**Lincoln Village Community Park Walkway Repair Project
Cordova Recreation & Park District
Addendum #1 Issued on Tuesday February 20, 2018**

**ADDITIONAL
CONCRETE @
PARKING LOT
PLAN**

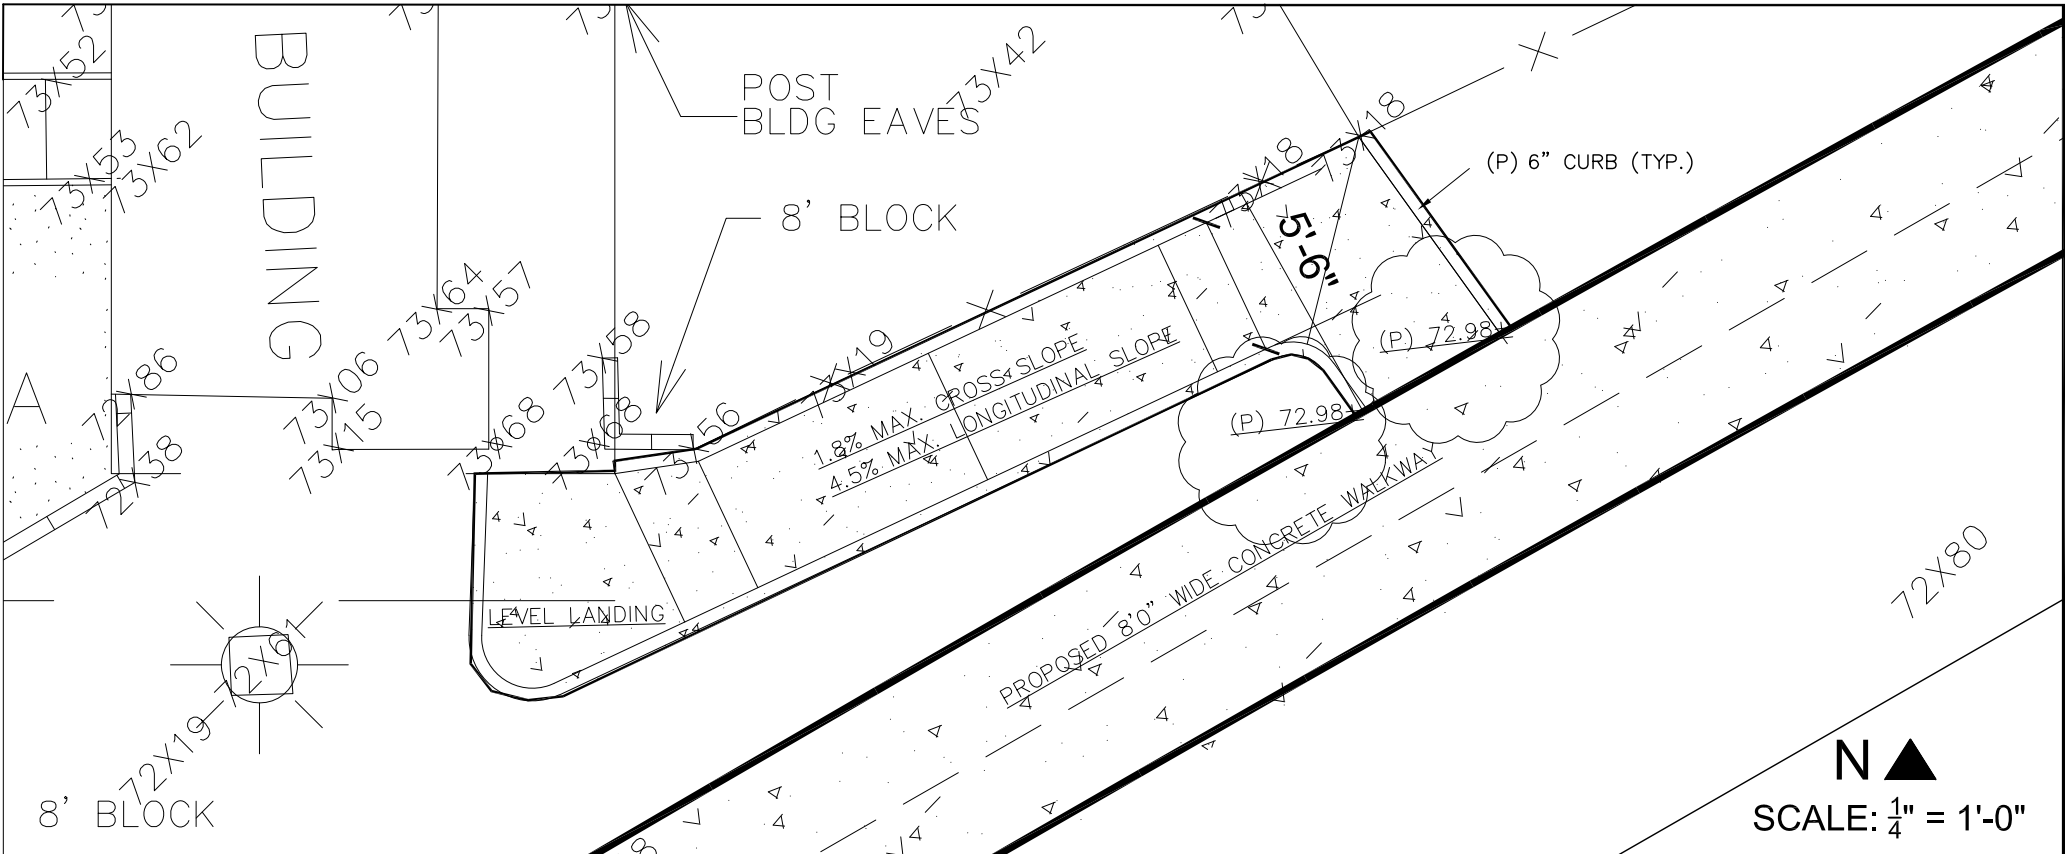
1. CHANGE: The curb adjacent to the tennis court shall be removed from this project. There is still concrete curbing around the proposed ramp to the pool area.
2. CLARIFICATION: A bid bond is required for this project. Industry standard form can be used.
3. CLARIFICATION: Please see detail attached for ramp to pool area with spot elevations.
4. Existing survey monuments in asphalt shall be removed.
5. CHANGE: Additional concrete walk has been added to the scope of work, please see attached plan.

Demolish existing
concrete, provide
new concrete with
truncated domes.
New concrete shall
be flush with new
asphalt paving.
